Subject: Duke Energy Carolinas, LLC
William States Lee III Nuclear Station - Docket Nos. 52-018 and 52-019
AP1000 Combined License Application for the
William States Lee III Nuclear Station Units 1 and 2
Response to Request for Additional Information
(RAI No. 2680)
Ltr# WLG2009.06-06

Lee Nuclear Station Response to Request for Additional Information (RAI)

RAI Letter No. 069

Reference NRC RAI Number(s): RAI 02.04.03-006

Revised FSAR Figure 2.4.3-227

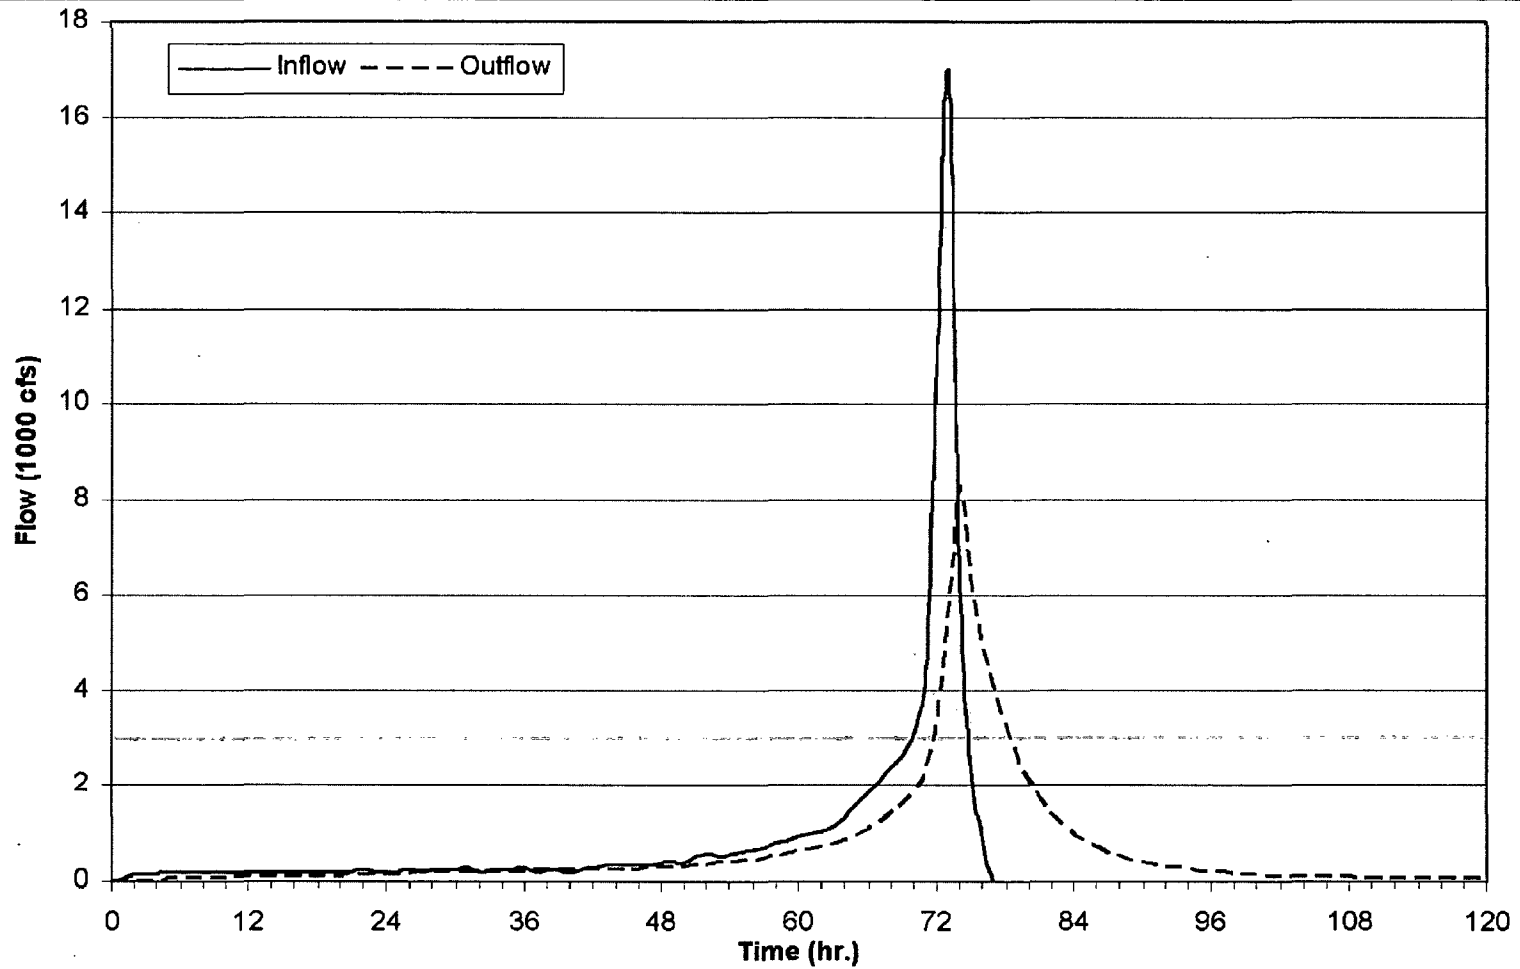
The NRC staff identified that the effect from wind-driven waves was determined prior to the consideration of nonlinearity effects. The staff theorized that the impact from wind-driven waves (0.38 ft.) could be higher due to a slightly longer fetch resulting from a slightly higher stillwater flood elevation considering nonlinearity (0.40 ft.). Duke Energy re-analyzed the flooding scenario for Make-Up Pond B calculating the effects of wind-driven waves from a stillwater elevation that included nonlinearity.

Based on the above re-analysis, the revised flood height for Make-Up Pond B is 584.59 ft. msl (rounded to 584.6 ft. msl). This result is the product of the same three component parts

described above, but combined in a revised order: 1) the PMF, 2) the impact from assuming a nonlinear basin response at high rainfall rates, and 3) the calculated effects from wind-driven waves from a flood height that is the combination of components 1 and 2. The individual component parts had the following contribution: 583.85 ft. msl + 0.40 ft. + 0.34 ft. = 584.59 ft. msl. The only changes in the analysis were associated with the calculation of wind-driven waves. This component was influenced by three factors: 1) a minor increase in fetch length due to the use of a higher surface water elevation of 584.25 ft. msl, which would tend to increase the wind-driven wave contribution; 2) a minor increase in slope associated with the higher water surface elevation of 584.25 ft. msl, which would tend to increase the wind-driven wave contribution; and 3) the correction of minor computational errors, which over-predicted wave run-up height in the original analysis. The result of the re-analysis demonstrates that there is over 5 ft. of margin between the calculated flood elevation and the point where safety-related SSCs could be impacted. This conclusion demonstrates reasonable assurance that the plant, as proposed, has adequate protection from the worst-case external plant flood originating from Make-Up Pond B.

New FSAR Figure 2.4.3-237

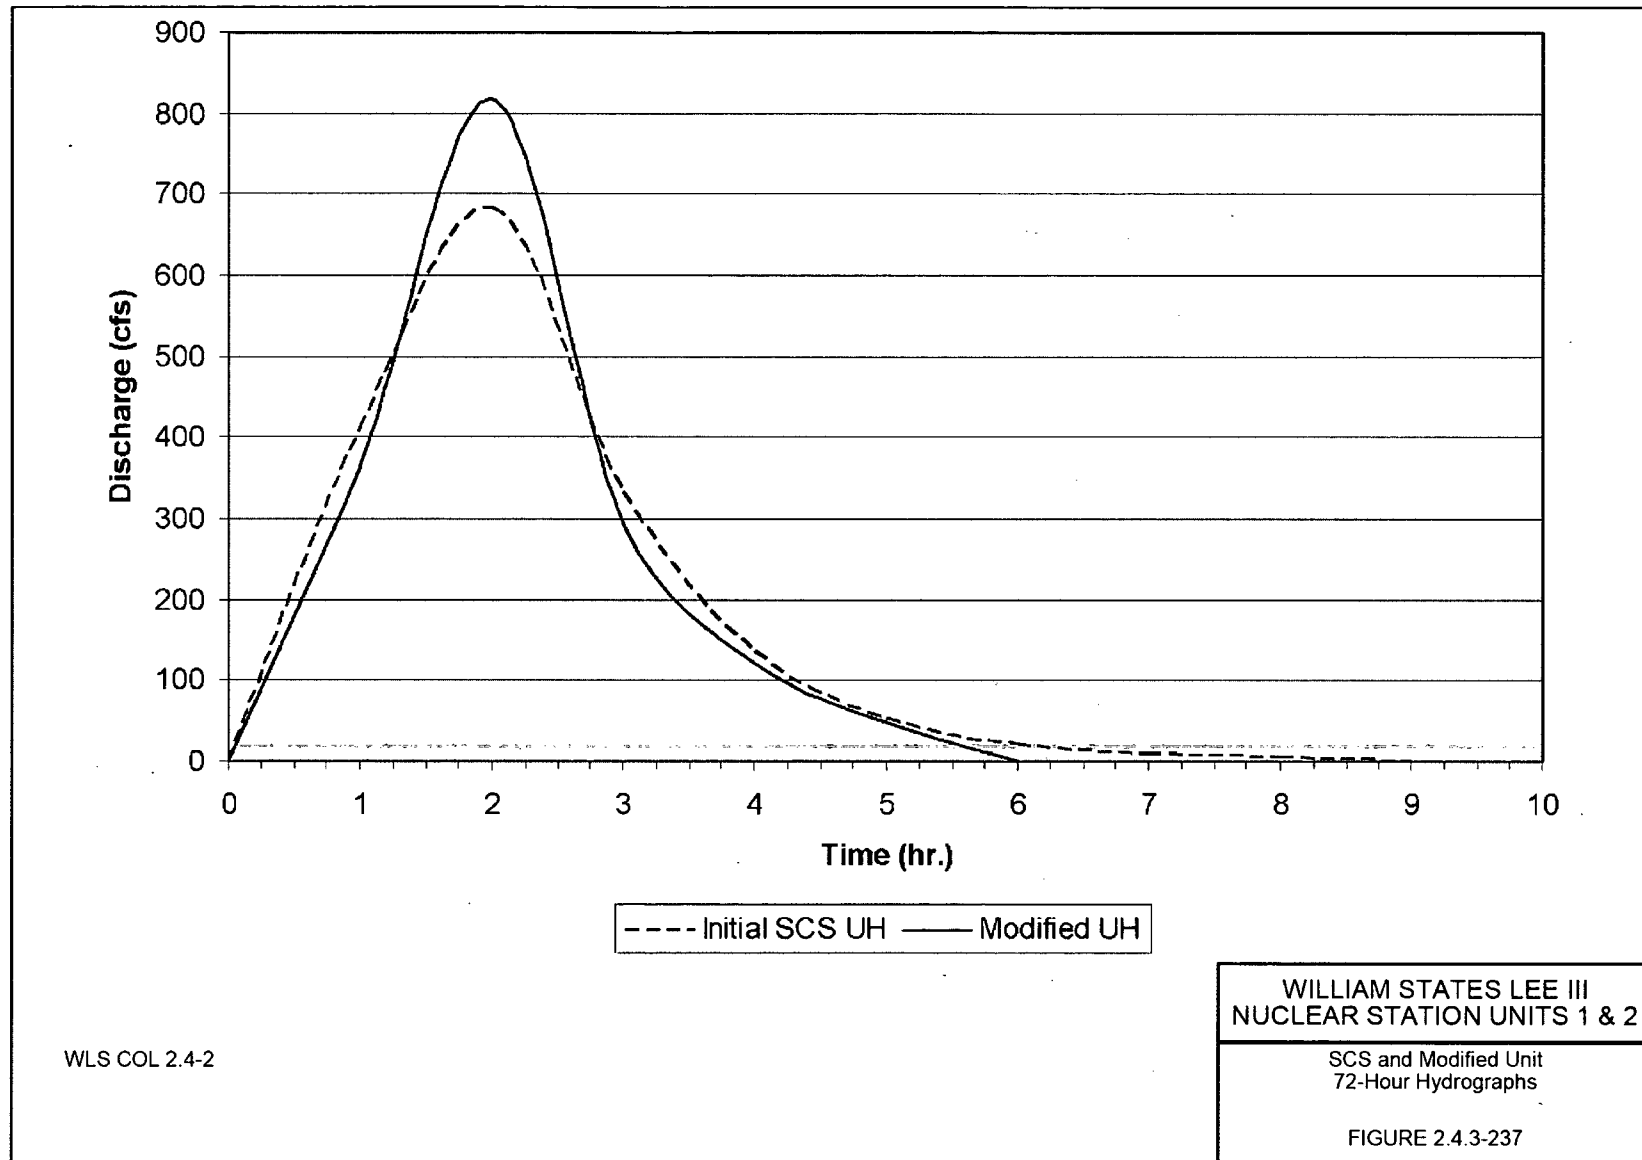
As discussed in the response to RAI 02.04.03-003 (Reference 1), nonlinear basin response for the Make-Up Pond B watershed was accounted for by increasing the peak of the associated derived unit hydrograph by 20 percent and reducing the time base by one-third.

The Soil Conservation Service (SCS) unit hydrograph method was used as a basis for a modified unit hydrograph to transform rainfall to runoff. Equivalent SCS unit hydrographs for the 72-hr. storm event and the 6-hr. storm event were first determined using the process of deconvolution, i.e., the known resulting flow hydrograph into Make-Up Pond B using the SCS unit hydrograph was used to back calculate an equivalent of the SCS unit hydrograph for the Make-Up Pond B watershed. The equivalent SCS unit hydrograph was then modified by increasing the peak of the unit hydrograph by 20 percent and reducing the time base by one-third. The remaining ordinates of the modified unit hydrograph were adjusted to maintain a smooth unit hydrograph with the standard characteristic of 1 in. of runoff. The 72-hr. storm event initial SCS unit hydrograph and modified unit hydrograph to account for the effects of nonlinear basin response are provided in Figure 2.4.3-237. The 6-hr. storm event initial SCS unit hydrograph and modified unit hydrograph to account for the effects of nonlinear basin response are provided in Figure 2.4.3-238.
